#### 01.06 Balcony lighting

6.0 Fifth floor

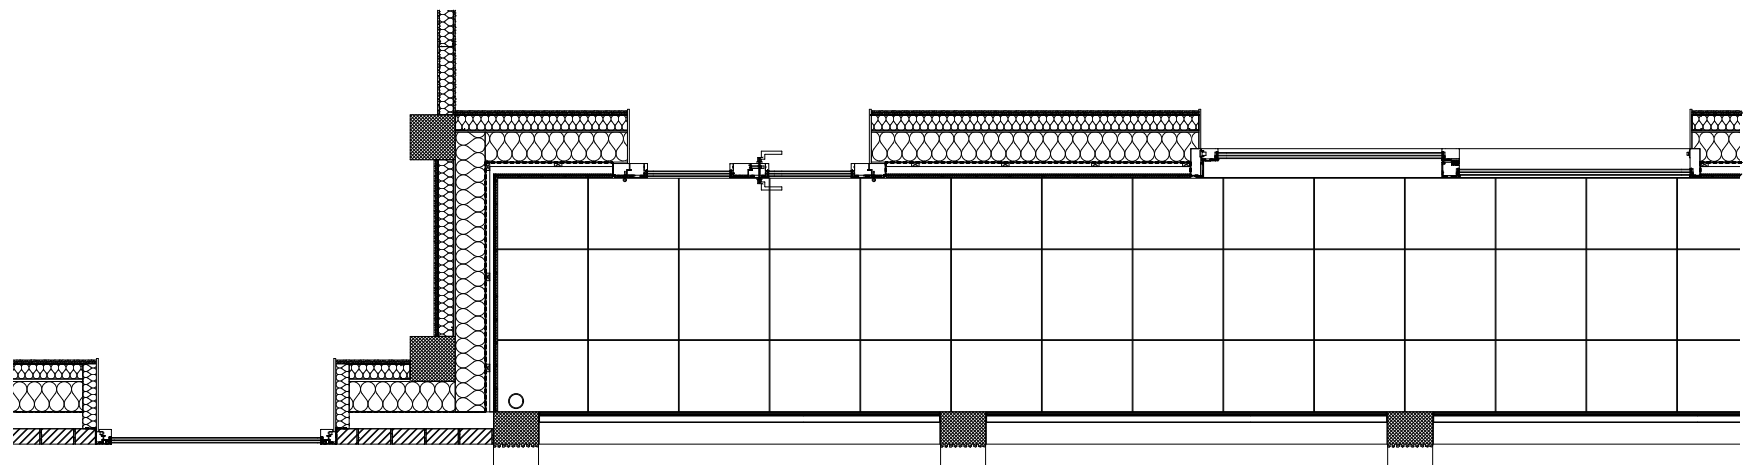
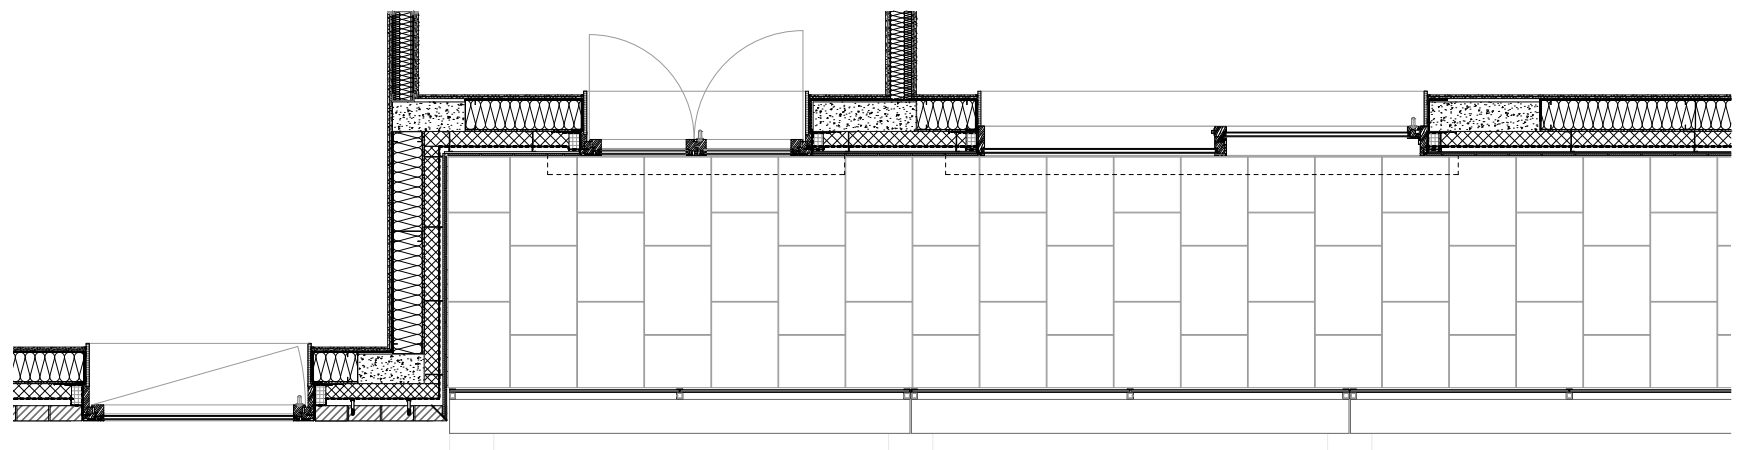
Lighting is required on the residential balconies so that these spaces can be used safely after dark. Condition 9 to the permission prohibits the addition of external lights. The proposed fitting would direct light down, illuminating the surface of the wall and the floor and will supplement the light spilling from the apartment interiors without producing a direct visible light which would be a nuisance to neighbours. We think this is a reasonable design solution and would like it to be considered as a revision to the application.

Typical condition of the residential elevation revised with the stone elements in the spandrel divided into three and the balcony lighting added.

Revised fifth floor plan with amendments marked in red

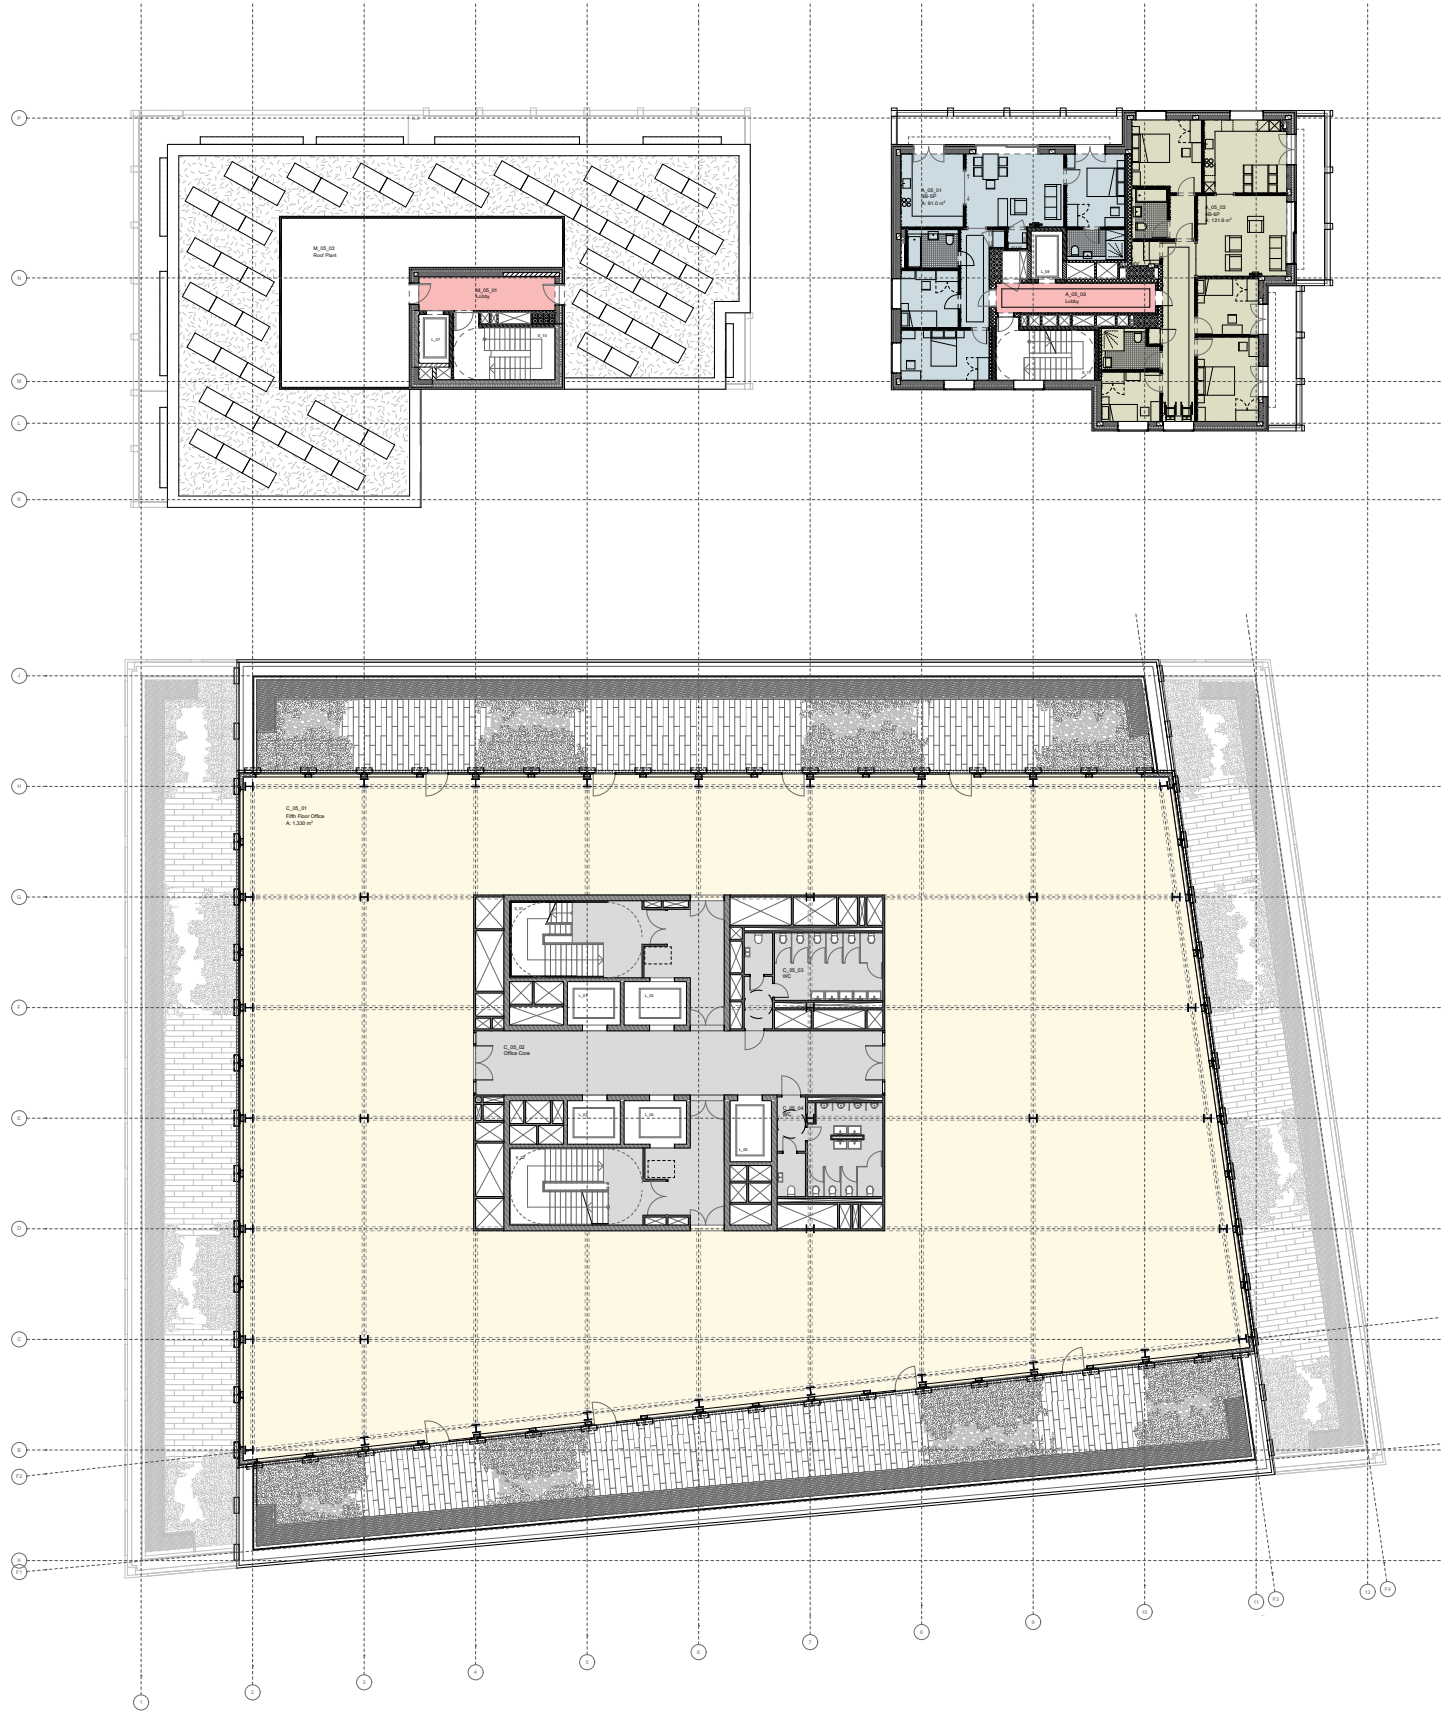
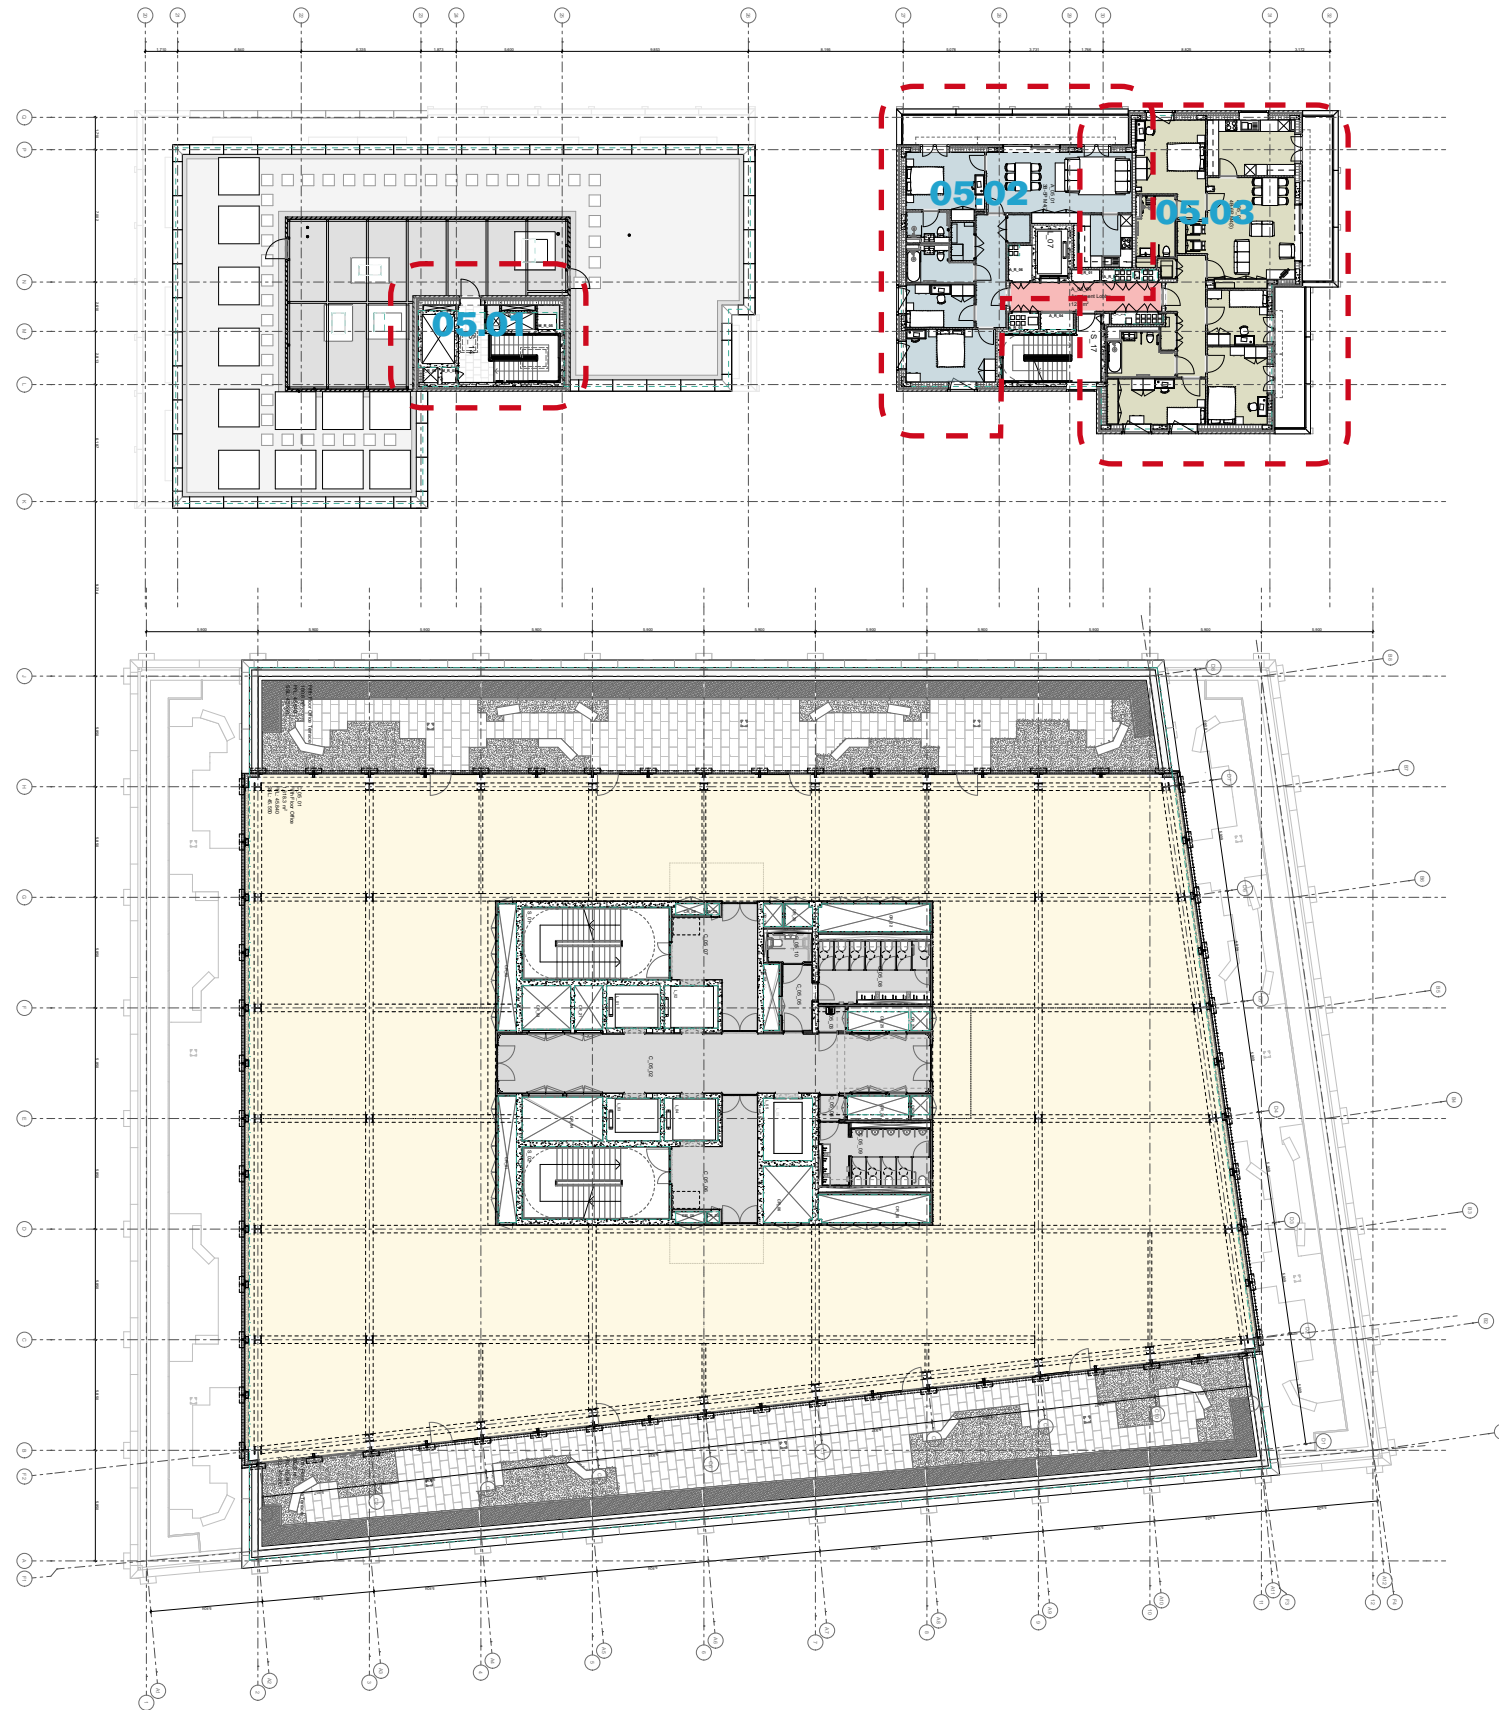
**05.01 - External circulation at rooftop level is reduced. See revised area table.**

**05.02 -Apartment layout adjusted to provide bedroom with access directly from hallway rather than through living room.**

**05.03 - Configuration of M(4)3 apartments updated to provide required movement zones.**

05.02 Apartment A\_05\_01

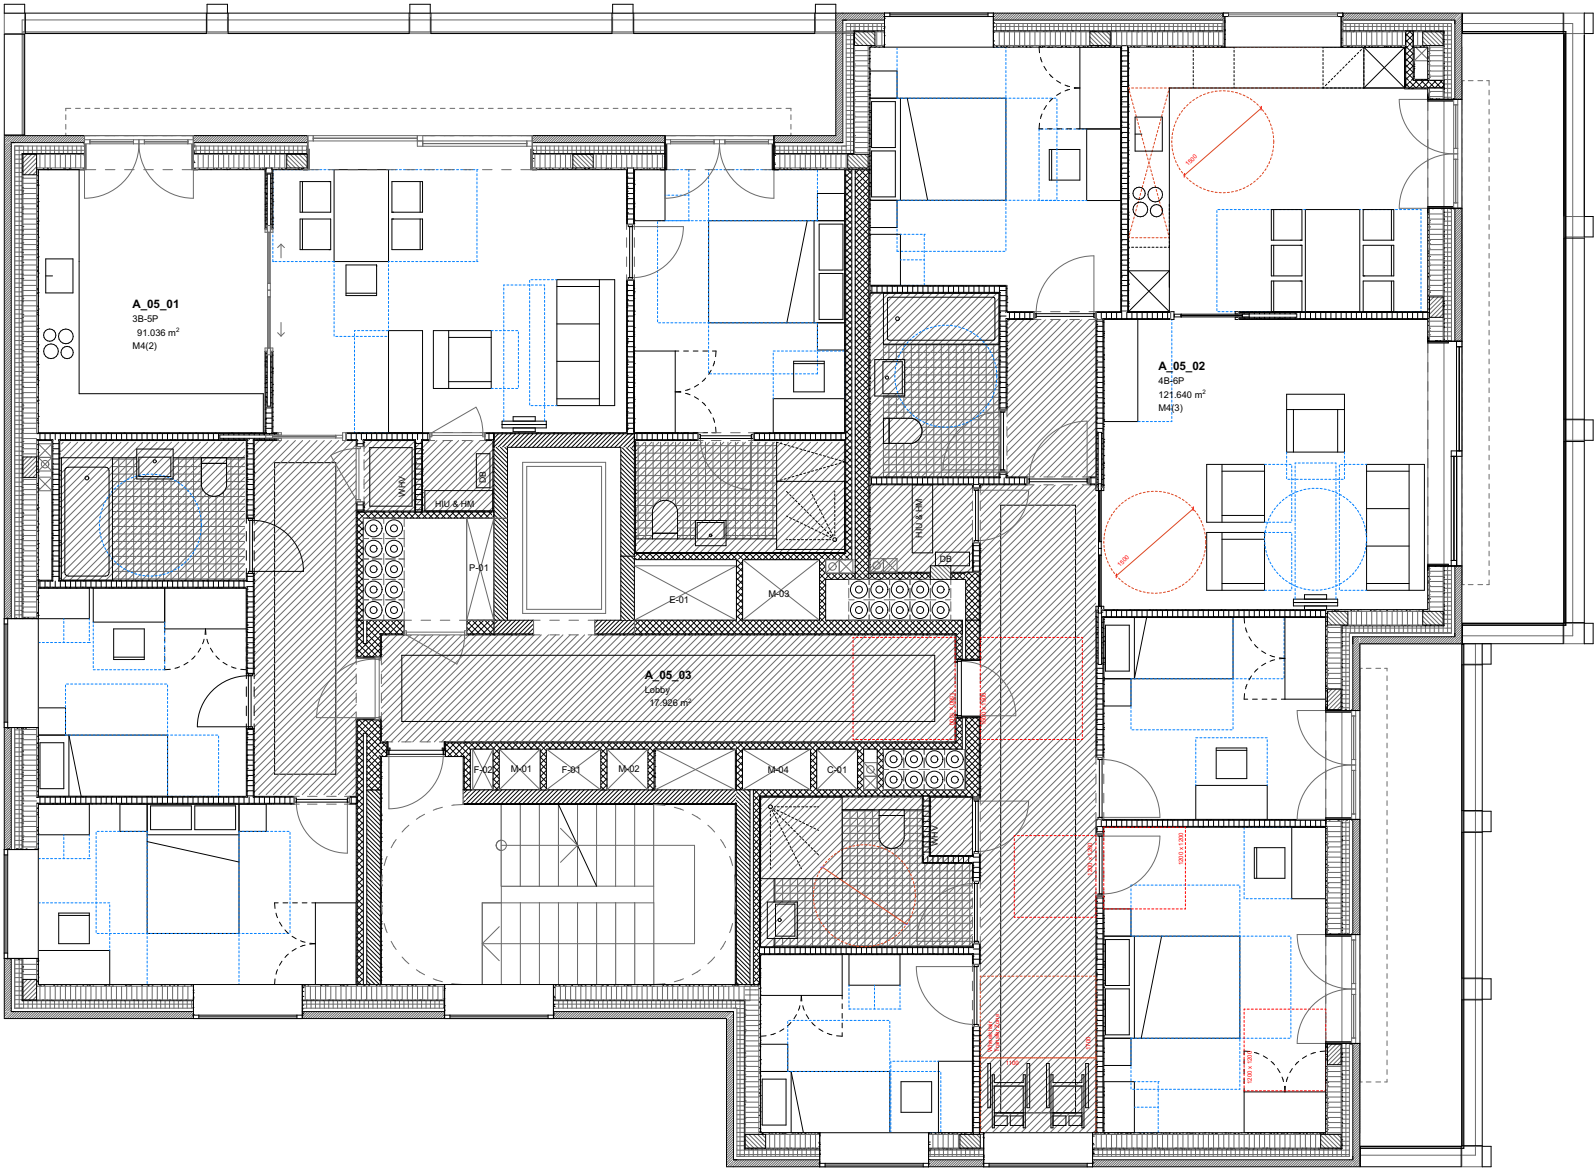
The master bedroom and kitchen of this 3-bed 5-person apartment have been flipped as an improvement to the emergency escape strategy.

05.03 Apartment A\_05\_02

The internal layout of this apartment was altered to meet the requirements set out in approved document M for a M(4)3 fully accessible dwelling.
